# UNITED STATES PATENT AND TRADEMARK OFFICE

APPLICATION NO.	FILING DATE	FIRST NAMED INVENTOR	ATTORNEY DOCKET NO.	CONFIRMATION NO.
09/613,294	07/10/2000	Peter Hauber	BLDR-01	9656

## Office Action Summary

### DETAILED ACTION

Attachment #2

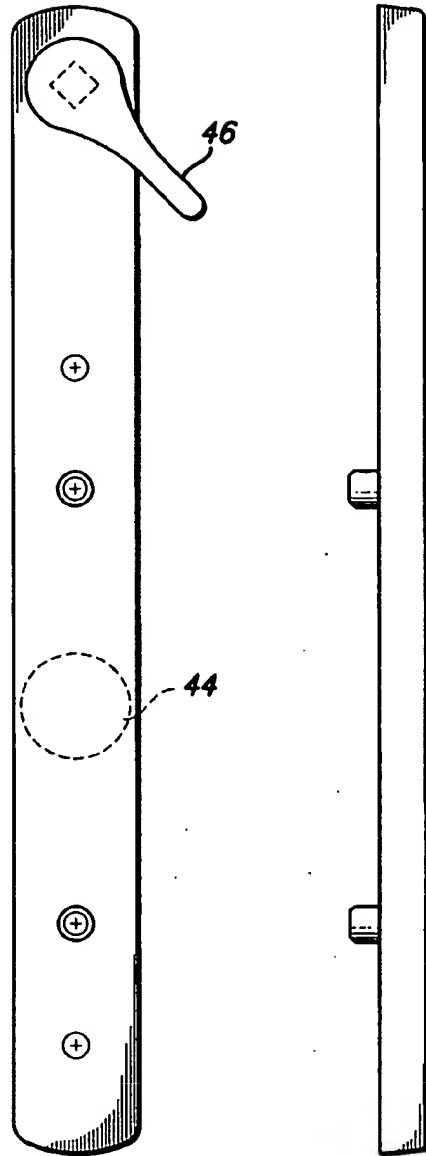
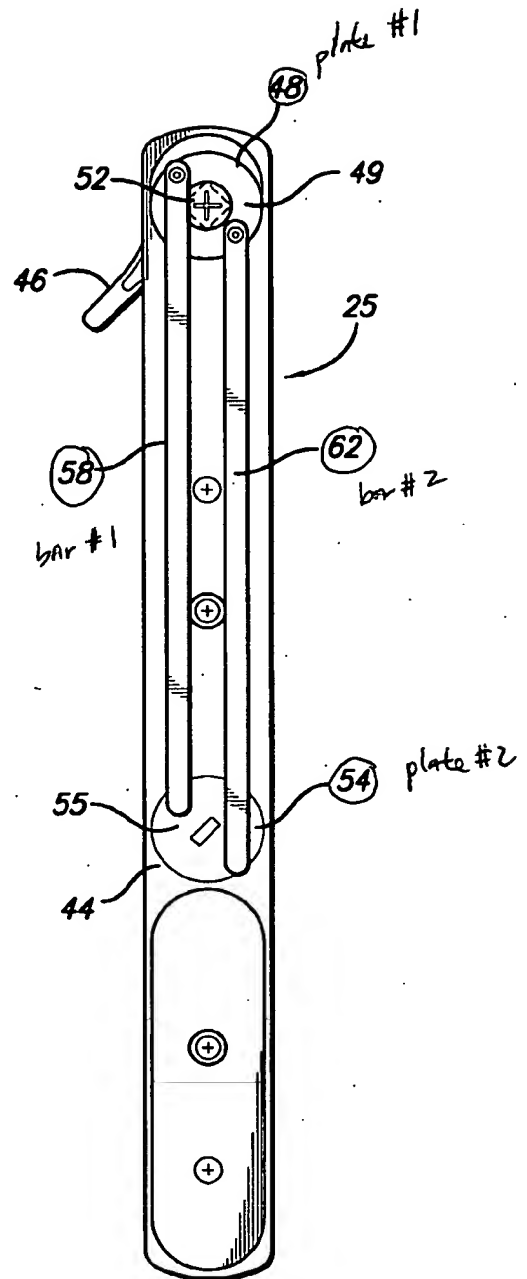
2. The drawings are objected to under 37 CFR 1.83(a). The drawings must show every feature of the invention specified in the claims. Therefore, the 4-bar coupling, as claimed in claim 13, must be shown or the feature(s) canceled from the claim(s). No new matter should be entered.

As seen in Attachment #2, the drawing only shows a 2-bar coupling, not a 4-bar coupling.

As to claim 13, the limitation "4-bar coupling" will be considered as a "2-bar coupling" since the drawings only illustrates two bars, not 4 (see Attachment #2).

First, the applicant fails to show a 4-bar coupling. The applicant believes that the combination of elements 48,54,58 and 62, as seen in Attachment #2, create a 4-bar coupling. However, the applicant is wrong by asserting this.

Elements 48 and 54 are rotatable latch plates and elements 58 and 62 are bars coupled to these plates. Therefore, it is only a 2-bar coupling, not a 4-bar coupling.

Corrected drawing sheets are required in reply to the Office action to avoid abandonment of the application. Any amended replacement-drawing sheet should include all of the figures appearing on the immediate prior version of the sheet, even if only one figure is being amended. The figure or figure number of an amended drawing should not be labeled as "amended." If a drawing figure is to be canceled, the appropriate figure must be removed from the replacement sheet, and where necessary, the remaining figures must be renumbered and appropriate changes made to the brief description of the several views of the drawings for consistency. Additional replacement sheets may be necessary to show the renumbering of the remaining figures. The replacement sheet(s) should be labeled "Replacement Sheet" in the page header (as per 37 CFR 1.84(c)) so as not to obstruct any portion of the drawing figures. If the examiner does not accept the changes, the applicant
